INFORMATION HANDOUT

For Contract No. 01-0B3504

Geotechnical Design Recommendations, Maple Stabilization Project

Subject: Addendum to Geotechnical Design Recommendations, Maple Stabilization Project

Figure 4. -- Typical design details.

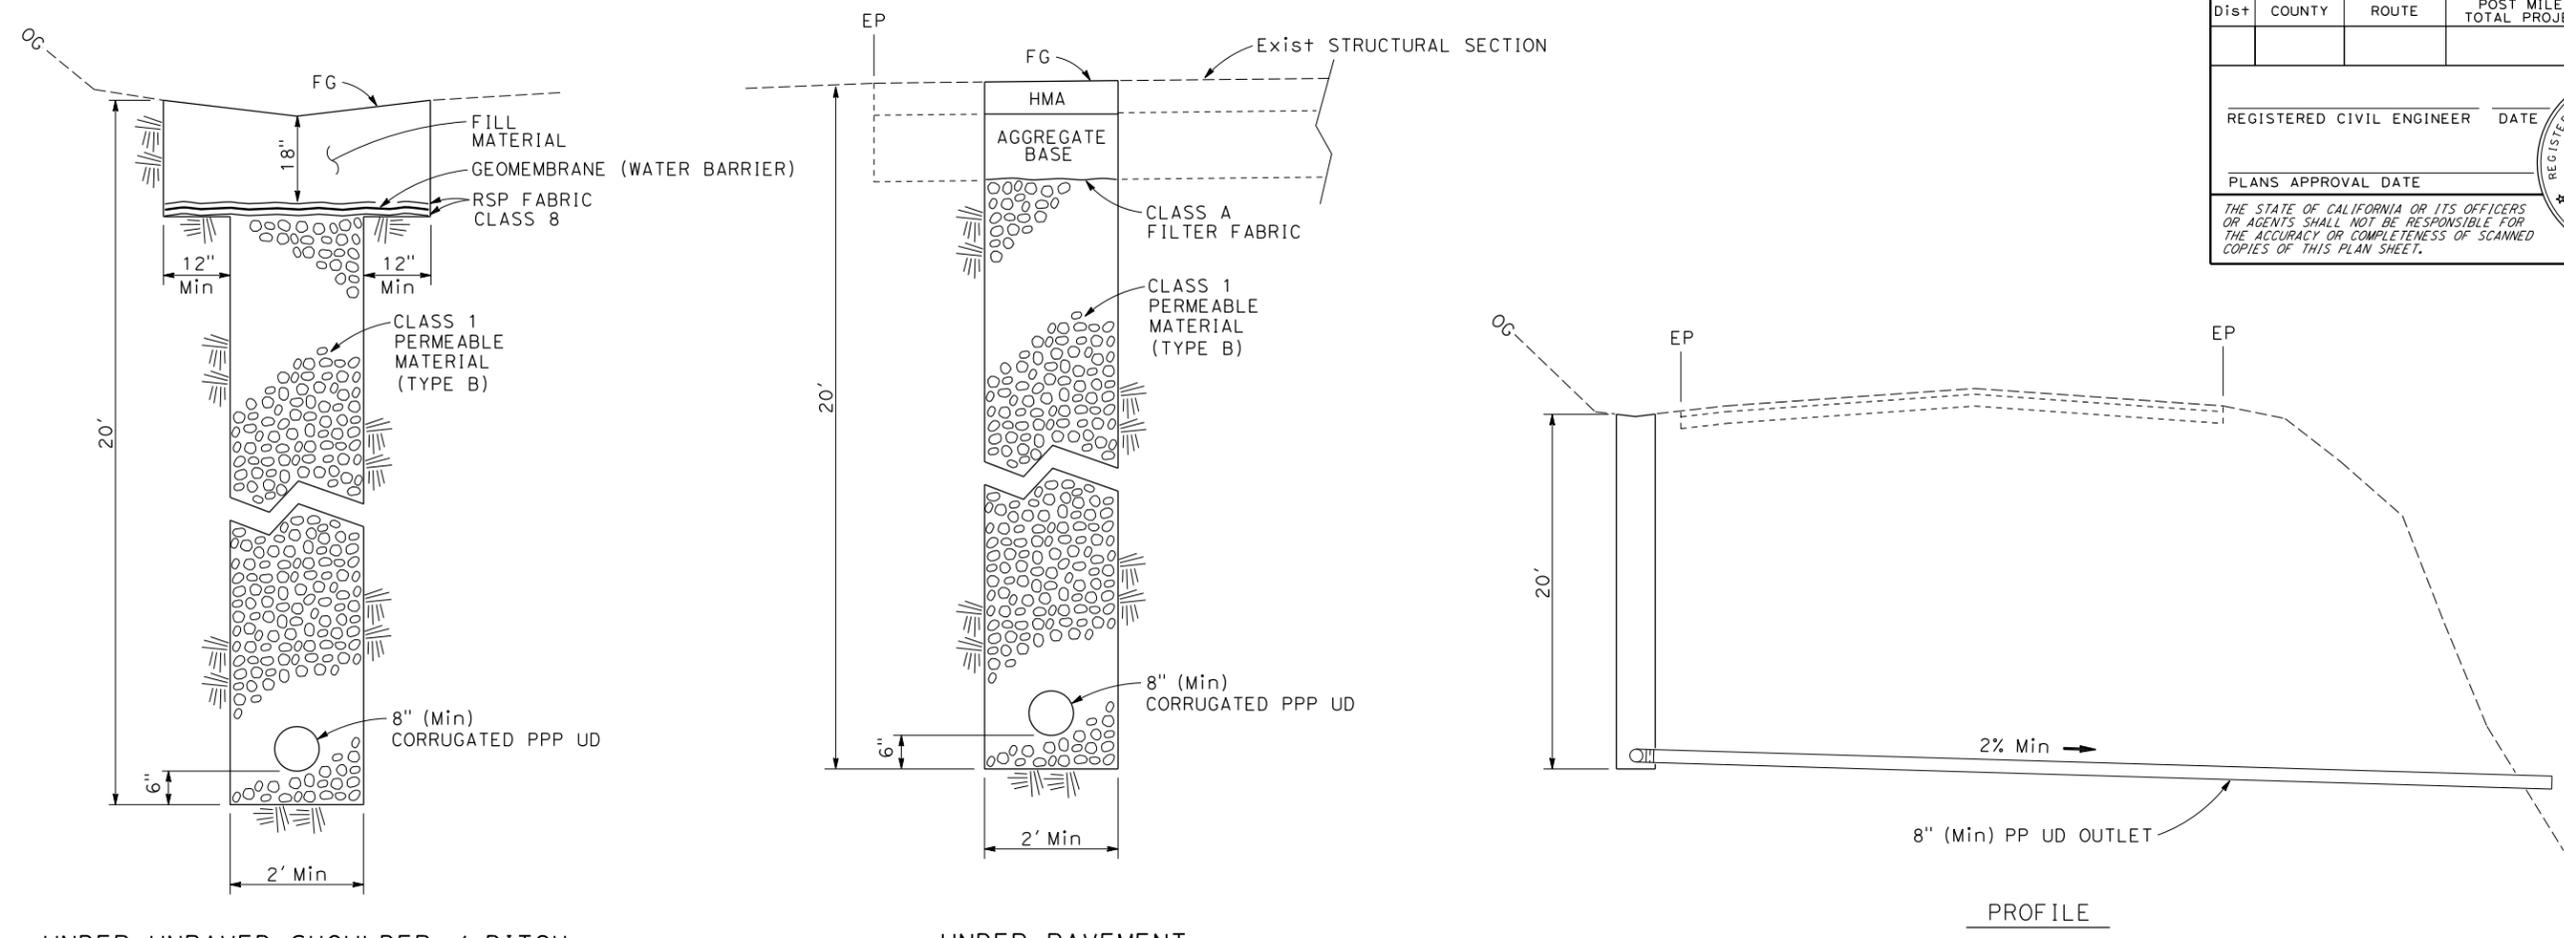
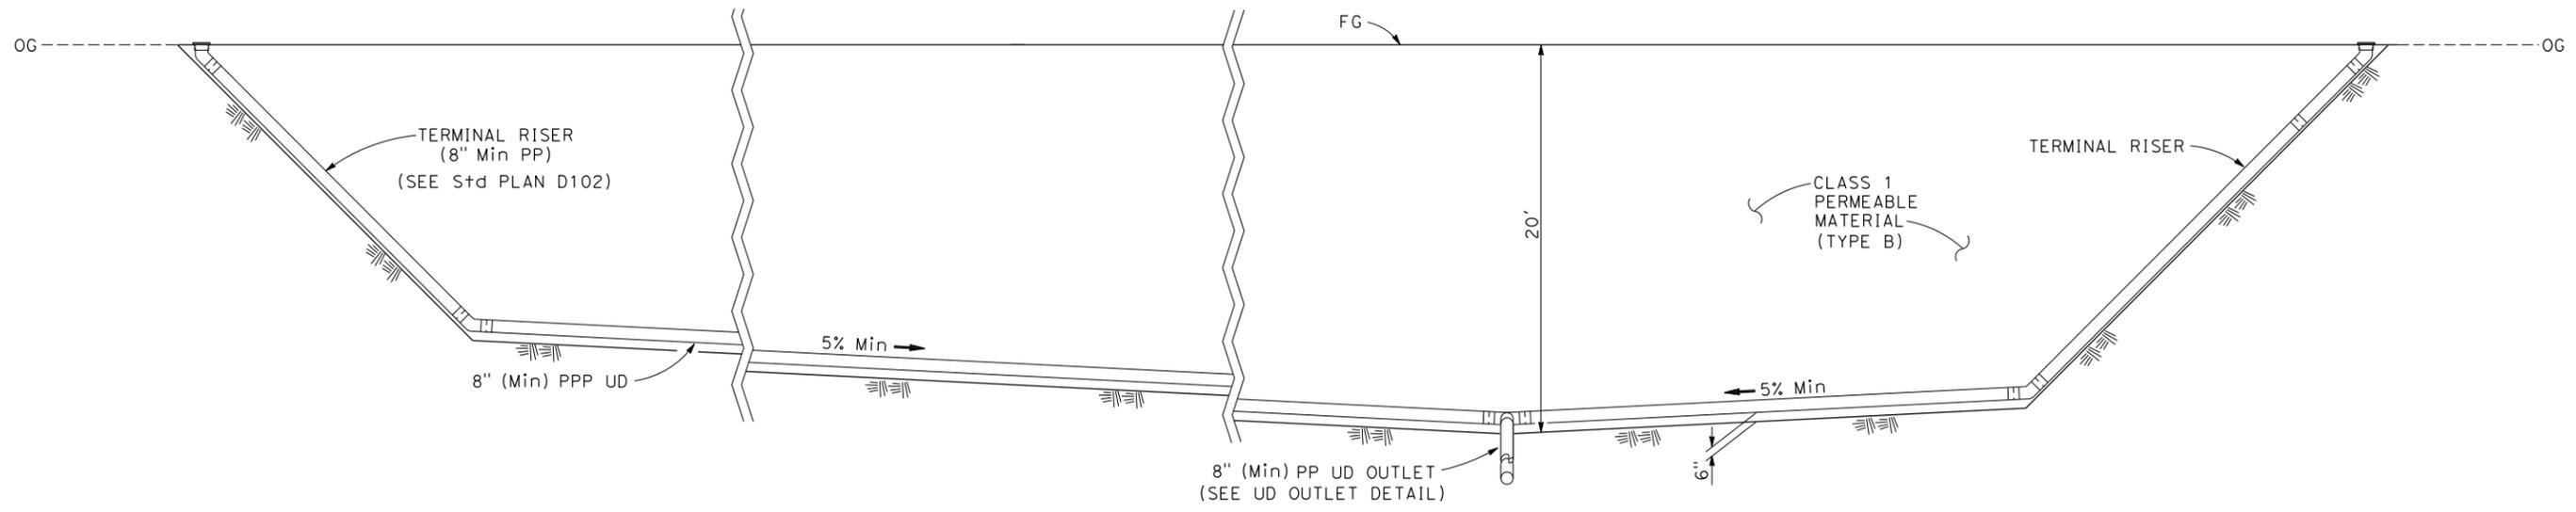
1. Construct the underdrain a minimum of four feet wide.
2. Omit the corrugated, fully perforated plastic pipe and terminal risers recommended in the April 25, 2013 Memorandum because the underdrain is to be constructed beneath pavement.
3. The bottom 4 feet of the underdrain trench should be constructed of Class 4 Permeable Material.
4. Filter Fabric Class A should be placed above the Class 4 Permeable Material.
5. The remainder of the trench should be constructed of Class 1 Permeable Material (Type B).
6. Overlay the Class 1 Permeable Material (Type B) with 1.6 feet of slurry cement backfill as shown on DD-1 of the plans.
7. The outlet for the underdrain should be 12 inches in diameter and be installed via auger boring.
8. The inlet of the outlet pipe should be perforated for a distance of 1.5 feet.
